TULSA ESTATES SUBDIVISION, **RESUBDIVISION OF LOT 5**

APPLICATION NUMBER 5 DATE February 18, 2021

DETAIL SITE PLAN

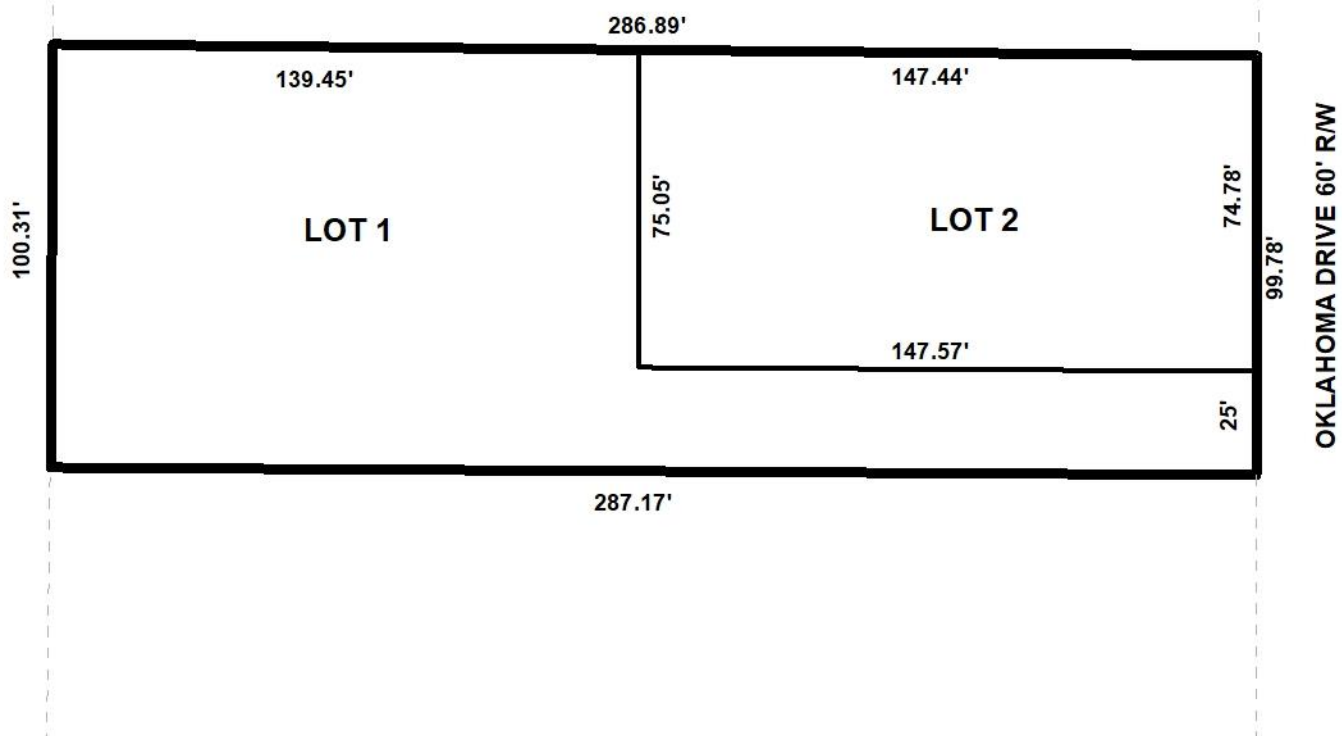
The 25' minimum building setback line required by section V.D.9 of the Subdivision Regulations is not illustrated on either lot. If approved, the plat should be revised to illustrate the 25' minimum building setback line where each lot is at least 60' wide.

Proposed Lot 1 is irregularly shaped and may be regarded as a "panhandle" lot. Such a lot design is generally discouraged by Section V.D.1. of the Subdivision Regulations, the exception being the approval of lots located where varied and irregularly shaped lot designs are common, and the informality of design is consistent with other lots in the vicinity. The Planning Commission has approved a similar design for several lots within the vicinity of the subject site, therefore a waiver of Section V.D.1. may be appropriate.

The lots meet the minimum size requirements for lots served by public water and sanitary sewer systems, but are not labeled with their sizes in square feet and acres on the preliminary plat. This information should be provided on the revised plat, if approved, or provision of a table on the Final Plat providing the same information may suffice.

- 1) revision of the plat to illustrate the 25' minimum building setback line where each lot is at least 60' wide;
- 2) provision of the lot sizes in both square feet and acres on the Final Plat, or provision of a table on the Final Plat with the same information;
- 3) compliance with Engineering comments: (*FINAL PLAT COMMENTS (should be addressed prior to submitting the FINAL PLAT for review and/or signature by the City Engineer): A) Provide all of the required information on the SUBDIVISION PLAT (i.e. signature blocks, signatures, certification statements, written legal description, required notes, legend, scale,*
